Work Order ID 82279

Item ID: D212-664-201

Item Name: Crosstube Aft

<b>DART AEROSPACE LTD</b>		<b>Work Order:</b>	82279
<b>Description:</b> Crosstube High Aft (205/212)		<b>Part Number:</b>	D212-664-201
<b>Inspection Dwg:</b> D212-664-241 <b>Rev:</b> D		<b>Page 1 of 1</b>

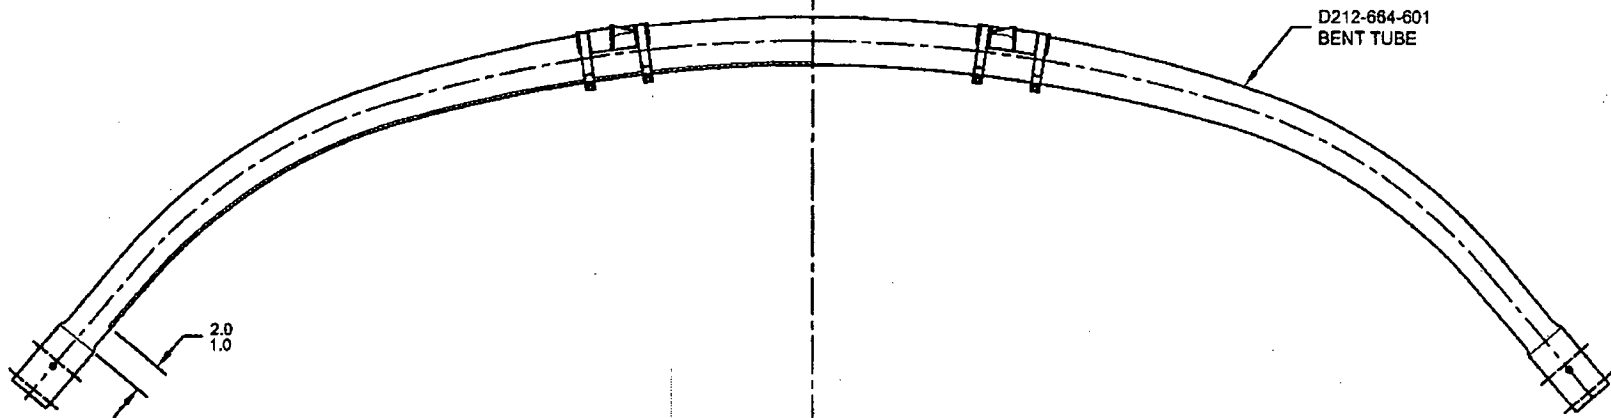
MASK AREA PRIOR TO PAINTING,  
REMOVE MASKING AFTER PAINT  
AND APPLY CLEAR COAT

CRUSHING OF D212-664-201

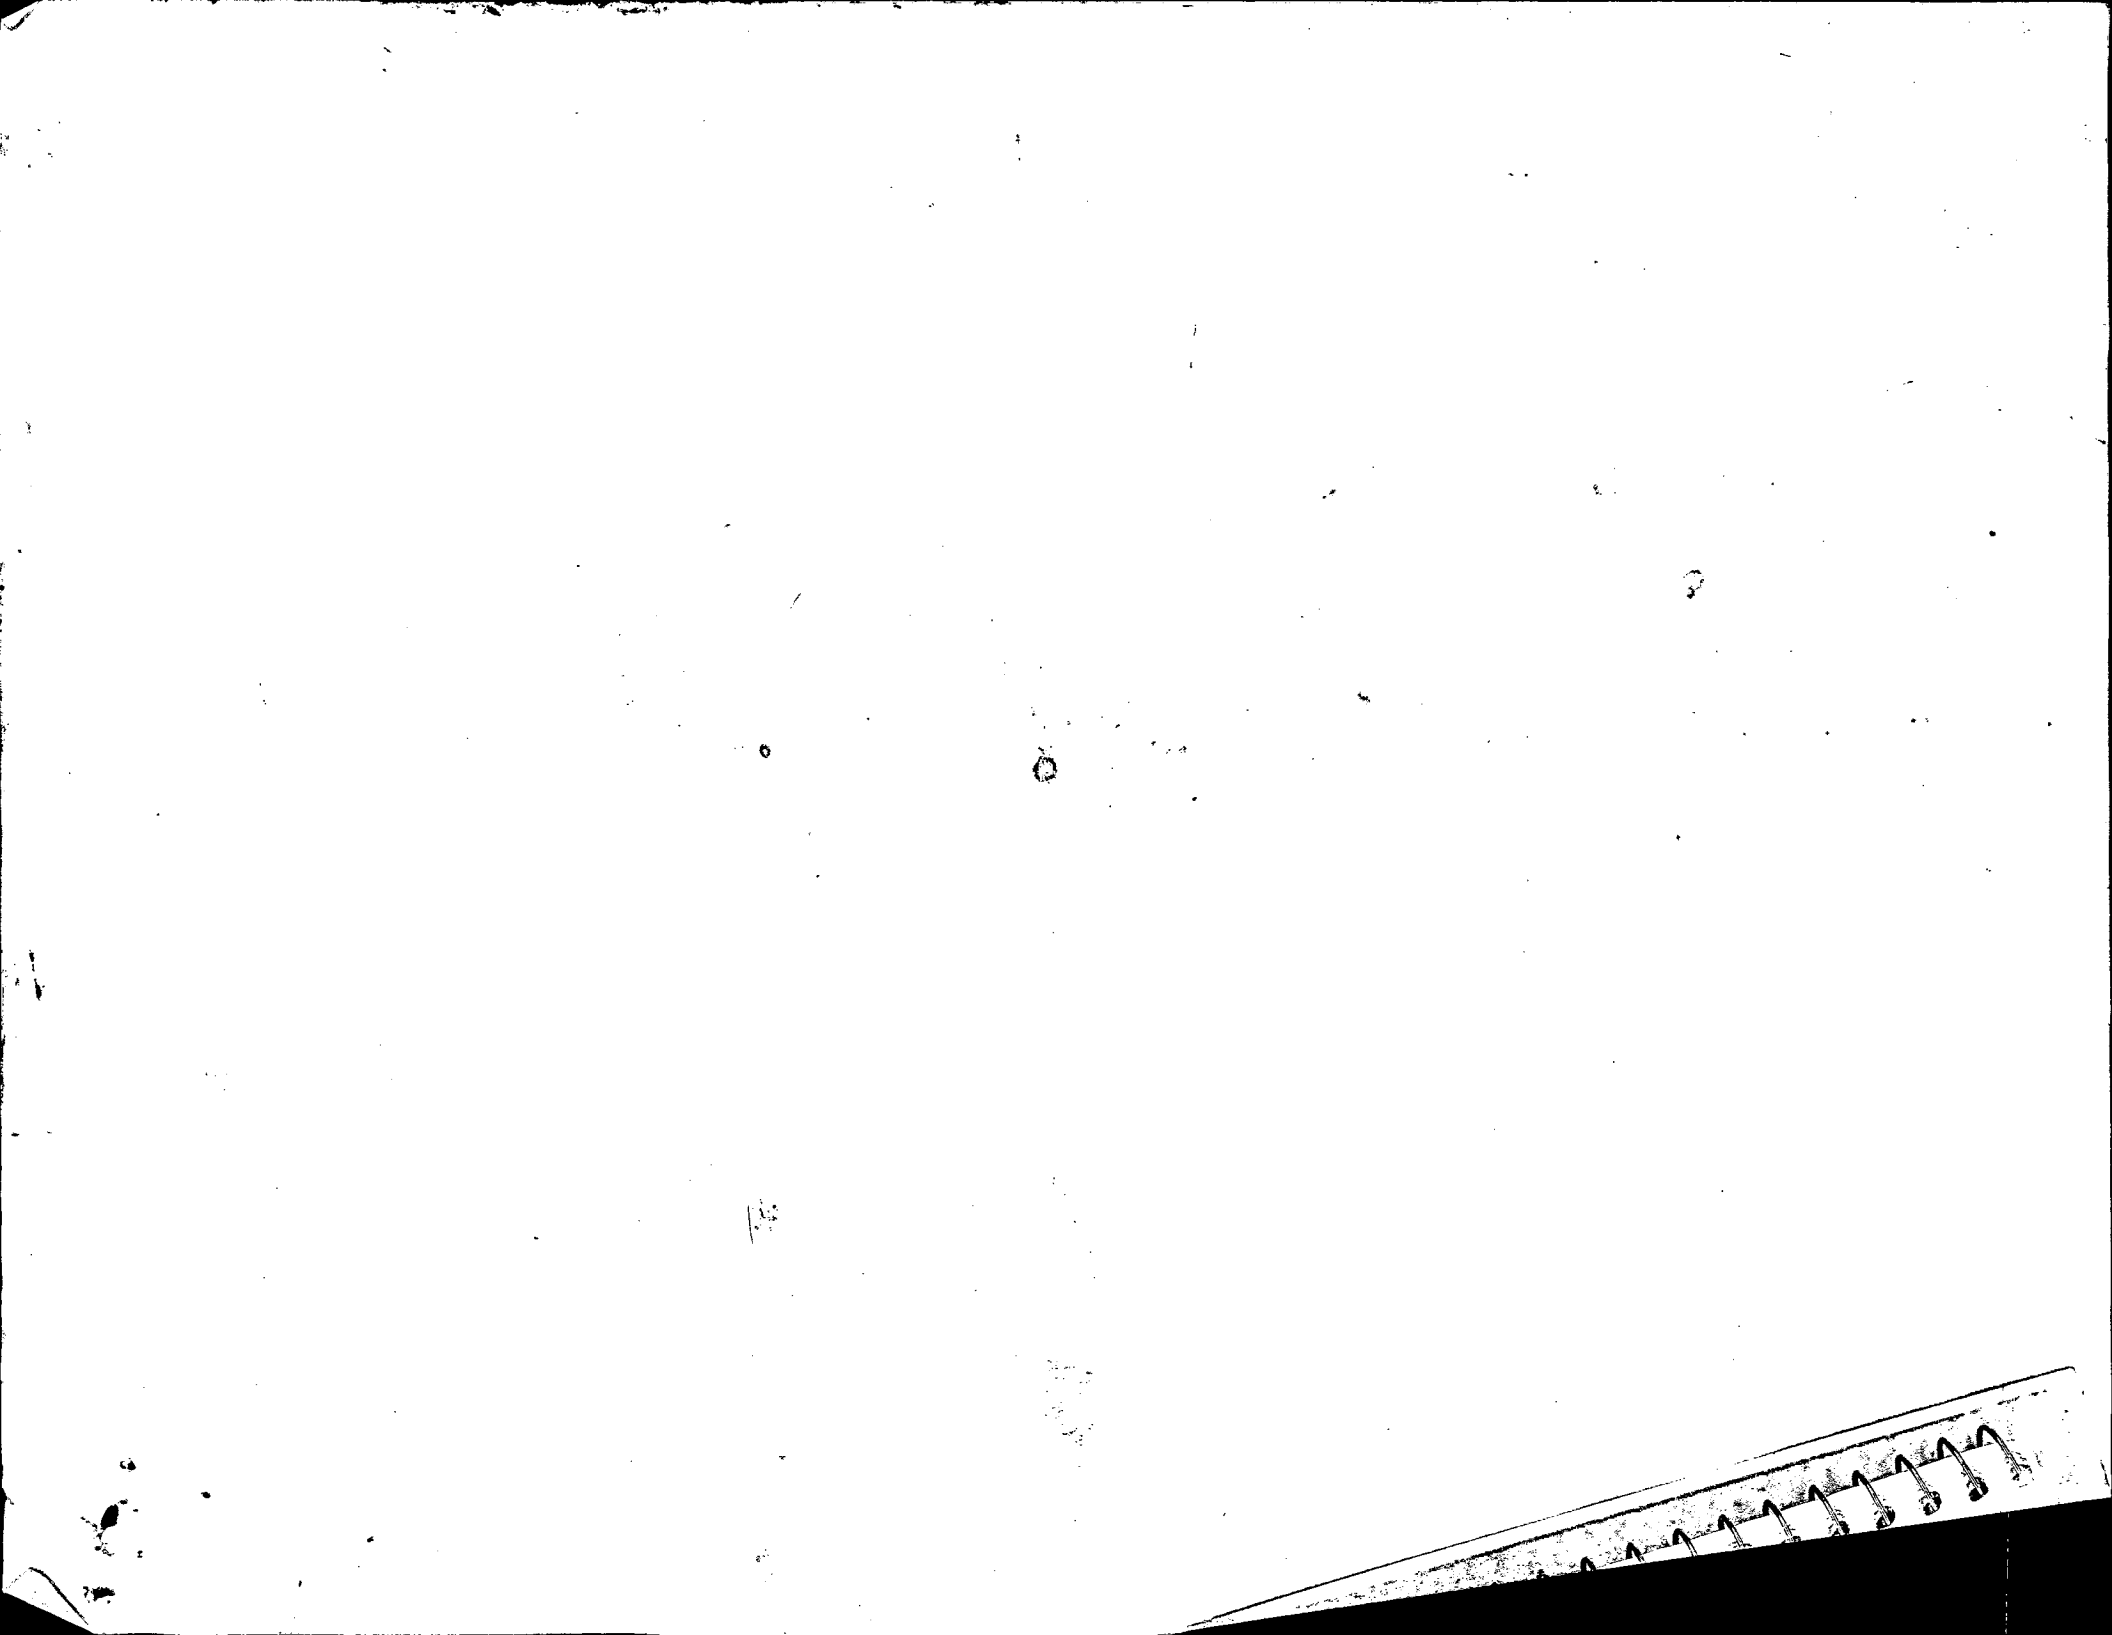
Acceptability of 8% CRUSHING

Point A:  $OD1 = 2.548 \text{ in}$   $OD2 = 2.442 \text{ in}$   
 $CRUSHING = (2.442 - 2.548) / (2.442 + 2.548) = 8\%$

Point B:  $OD = 3.25 \text{ in}$   $ID = 2.22 \text{ in}$   
 $I = 4.284 \text{ in}^4$

A:  $F = M_c / I = P \times 13.5 \times 2.548 / 2 \times 1.476 = 11.65 P$   
 B:  $= P \times 41.03 \times 2.442 / 2 \times 4.284 = 14.32 P$

$MS = 14.32 / 11.65 - 1 = 0.22$

Tube will fail at support before area of 8% CRUSHING. 8% CRUSHING AT END OF BEAM IS ACCEPTABLE
